NOTICE NO. HN-145, 2*

*Supersedes Service Information Notice No. HN-145.1, dated 12 October 1979

SUBJECT: 100-HOUR PERIODIC INSPECTION - FUEL TANK SENDING UNIT AND FUEL LOW WARNING LIGHT INDICATING SYSTEM

MODELS AFFECTED: All 500 Model 369H Series Helicopters

Figure 1. Bench Test and Potting of Fuel Tank Sending Unit

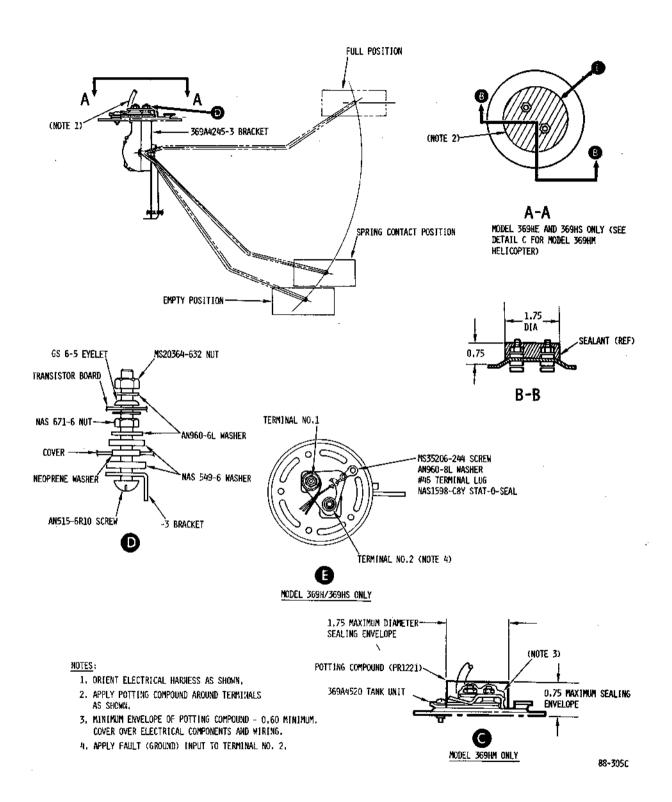
- (d) Apply potting compound to tank unit as shown in Figure 1, Detail A.
- (e) Cure until tack-free to touch.
- 2. PR1221 potting compound:

- (a) Clean area by wiping with Kimwipe moistened with Aliphatic Naptha.
- (b) Mix by weight, 10 parts white base compound and 1 part red-brown accelerator to uniform light brown color.
- (c) Apply mixed compound to tank unit as shown in Figure 1, Detail A or Detail C.
- (d) Cure for 36 hours minimum before being handled and 72 hours minimum before applying load.
- d. Using flashlight and pointed probe (wood or plastic), inspect interface of potting compound and sending unit mounting plate for voids. Pay particular attention to area around terminal screws (see Detail A, Figure 1). If any voids are noted, perform Part II of this Notice.

- c. Bench test sending unit per Section 17, Basic HMI; replace unit as required.
- d. For 369HE and 369HS commercial helicopters only, perform the following (see Figure 1, Detail D and Detail E):

- 1. Tighten NAS671-6 nut to hold 369A4245-3 bracket firmly in position.
 - 2. Disconnect and lift No. 46 ground terminal lug away from mounting plate flange; hold float arm at full position.

- 3. Resistance measured from -3 bracket to flange shall be greater than 2 megohms.
- e. Apply potting compound to seal voids, as applicable (refer to Part I, Step c for mixing and application of potting compound).

- a. Remove left side fuel cell access door (Section 2, Basic HMI).
- b. Remove existing RTV732 potting compound by scraping with dull knife or plastic spatula and then wipe with alcohol.
- c. Mix and apply RTV730 potting compound per manufacturer's instructions to fuel tank sending unit. (See Figure 1, Detail A)
 - d. Cure at ambient temperature for 48 hours.
 - e. Reinstall fuel cell access door.
- f. Record compliance with Part III of this Notice in Compliance Record of helicopter Log Book.
